City of Surrey
PLANNING & DEVELOPMENT REPORT

File: 7910-0279-00

Planning Report Date: June 13, 2011

in order to permit the development of a 4-storey apartment building.

UNDERGROUND PARKING PLAN

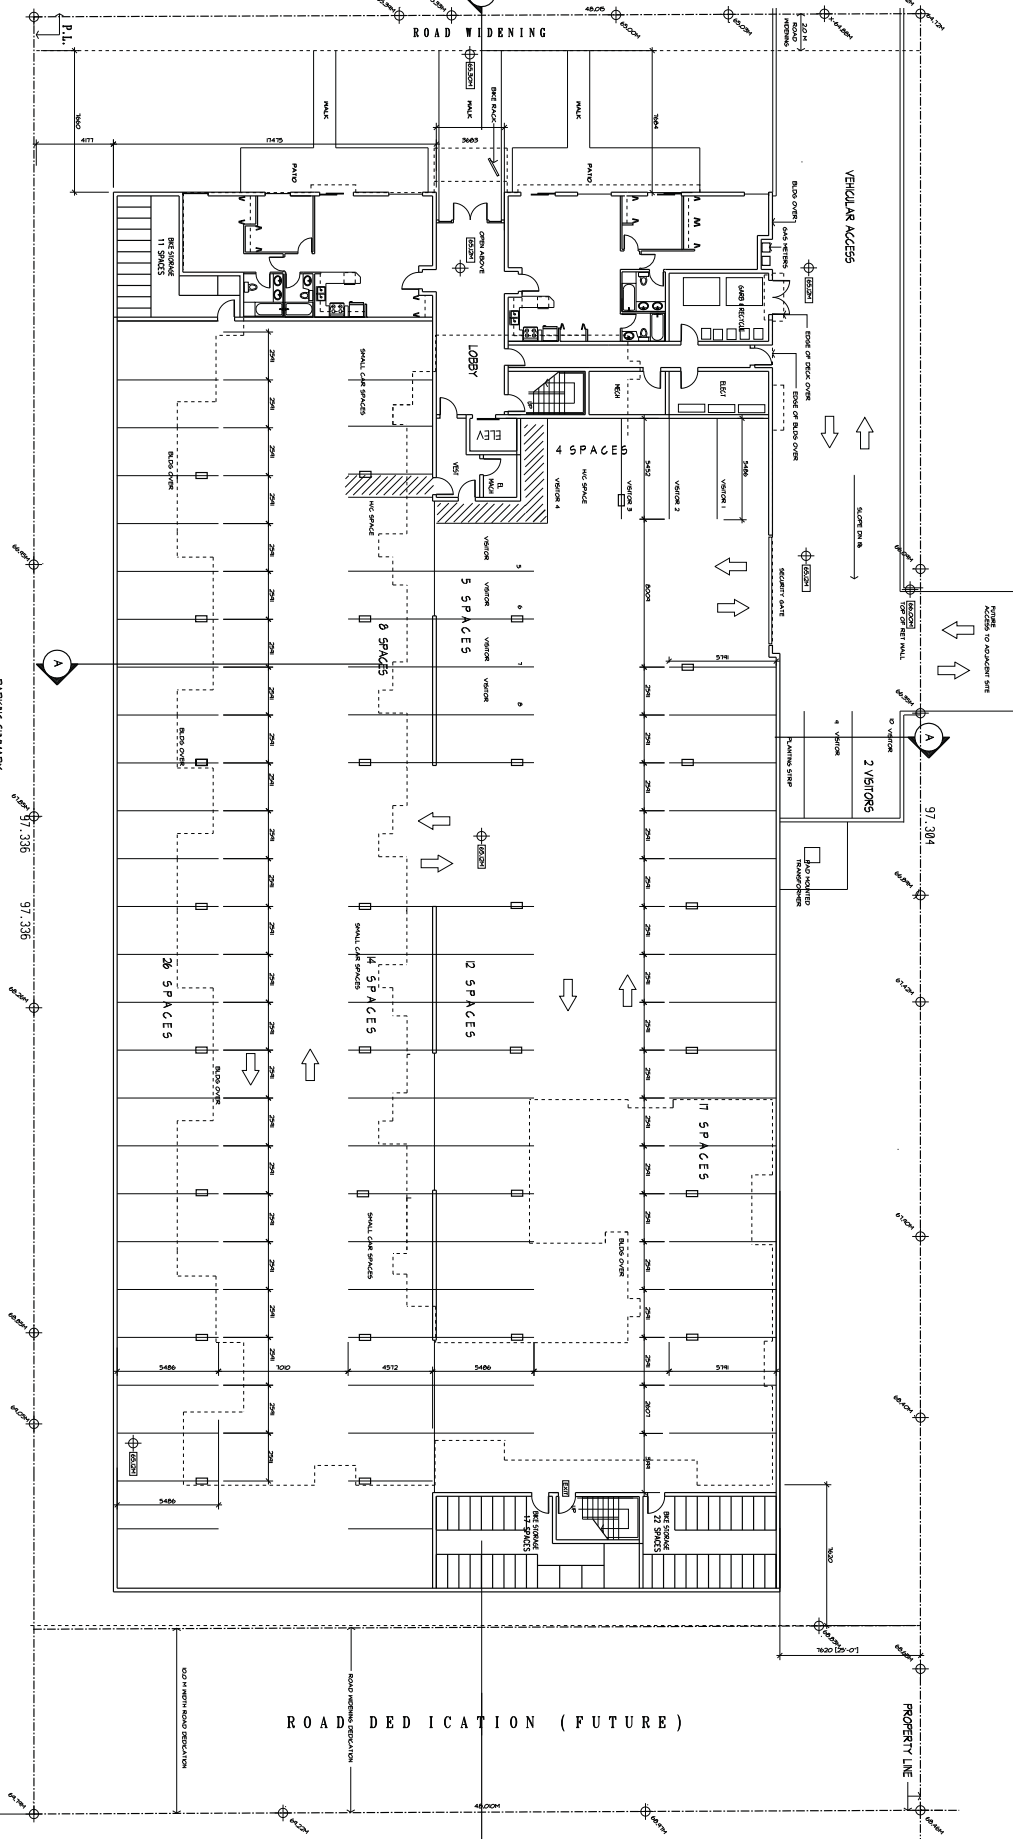
- Handicapped parking in the underground is still a fairly long distance to elevator – normally they are adjacent to the elevator
- Consider re-planning the E units and put bedrooms on the outside walls

<p>Accessibility</p> <ul style="list-style-type: none"> • Handicapped parking in the underground is still a fairly long distance to elevator – normally they are adjacent to the elevator • Consider re-planning the E units and put bedrooms on the outside walls 	<ul style="list-style-type: none"> • Handicapped stall has been moved closer to the elevator. • Will consider minor changes.
<p>Sustainability</p> <ul style="list-style-type: none"> • Response to sustainability - did not really respond to ADP's previous comments • Open walkway creates a possibility for cross ventilation for each suite but that also means twice the exterior wall area per suite. It would be nice to have this compensated for by slightly better insulation levels, better window performance. Could also consider heat recovery ventilation, hot water heat, and solar assisted domestic hot 	<p>The project addresses several sustainability issues. LEED credit numbers have been provided in brackets for reference where applicable:</p> <ol style="list-style-type: none"> 1. All but two of the parking stalls are covered, reducing the heat island effect and enhancing the landscaping of the site (SS 7.1). 2. The heat island effect of the project will be further reduced by providing a light coloured (high albedo) roof

NORTH ELEVATION (60th Avenue)

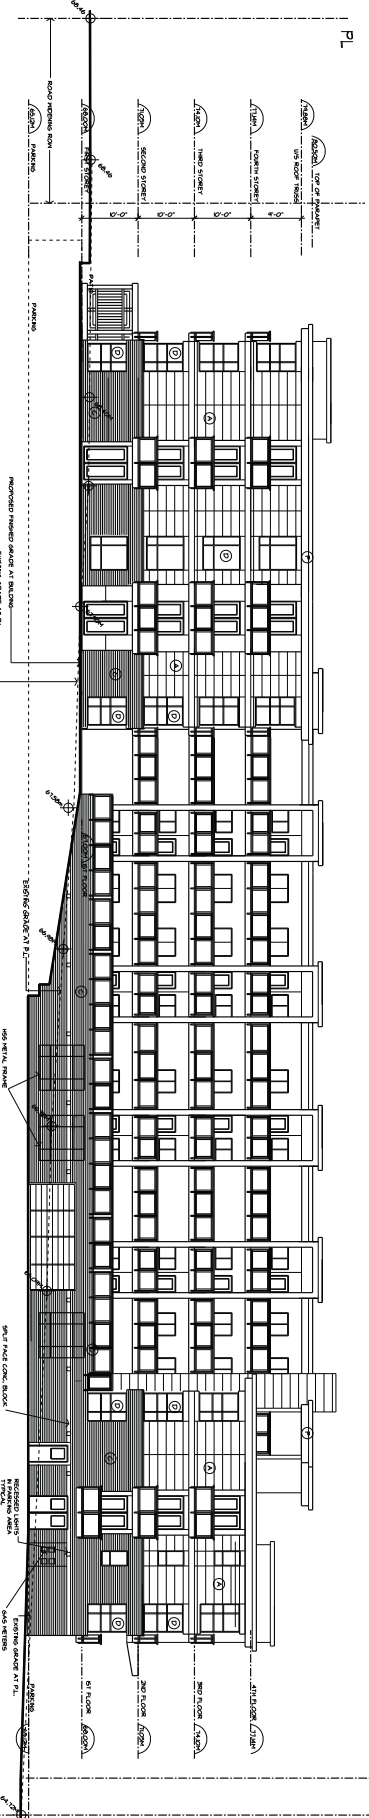
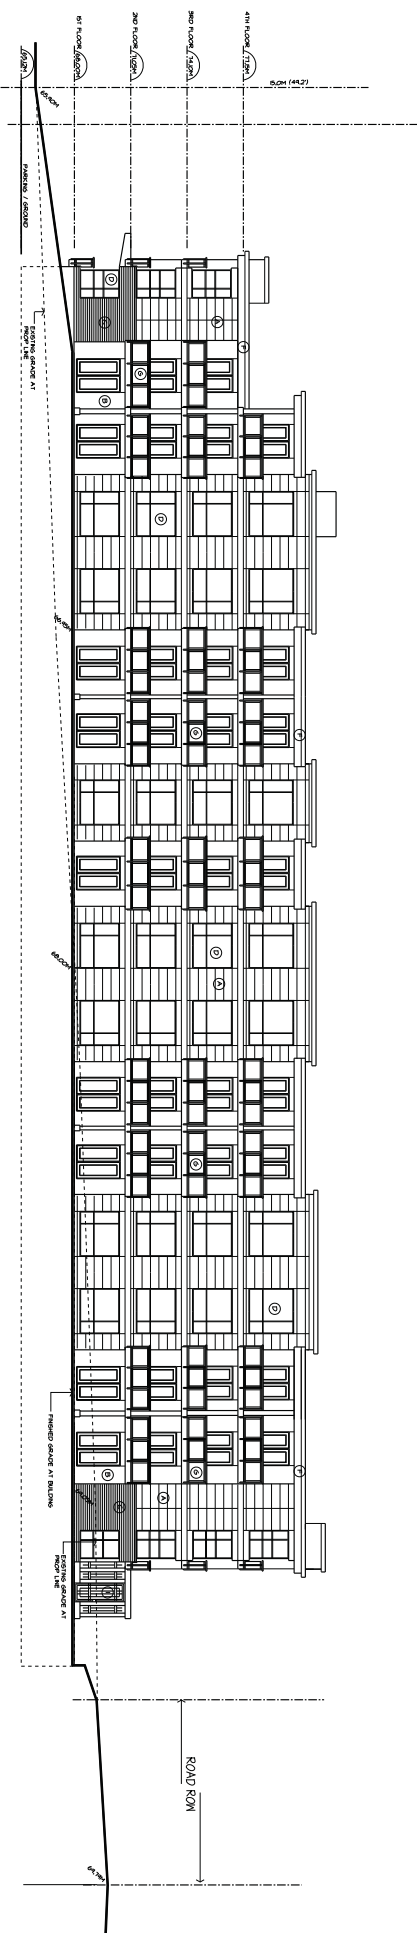
<ul style="list-style-type: none"> • Careful detail of corner windows and brick / panel junctions is needed • Detail of how materials come together is critical and not provided, e.g., corner windows need to go around the corner, suggest have less metal (at roof edge) but use it better; a lot of detail necessary for this building • Lobby would be better with full glazed door way – very careful interior design is required to mitigate its length • Front wall is not looking like a front wall yet with different entrances, etc.; needs to be abstracted so it feels like a front door instead of like a service entrance • Wall next to parking driveway needs to feel less like a service entry • Consider canopies over the two prime entrances • Special attention should be paid to the metal cornice detail to avoid oil canning and irregular seams • Take advantage of third floor roof as a terrace to fourth floor unit above • Could drop window sills in exercise room closer to grade on 60th Avenue. • Concern regarding below grade suites – suggest doing anything you can do to fine tune the grading and make it as usable as possible 	<ul style="list-style-type: none"> • Corner window with mullion will be used. • See details on drawing A13. • Lobby now has more glazing and elevator has been moved forward to shorten the length of the lobby. • The addition of the ground floor homes, the lobby at grade & stepping of the building has changed the look of the entryway. • More landscaping has been added and the brick has been broken up. • Canopy has been added at front entryway but not at the back. • Cornice detail has been changed-see details on drawing A13. • For privacy issues & noise we don't feel that roof decks should be above suites. • The exercise room has been moved. See 60th Avenue elevation drawings A8. • The building has been raised 3' improving the relationship with grade.
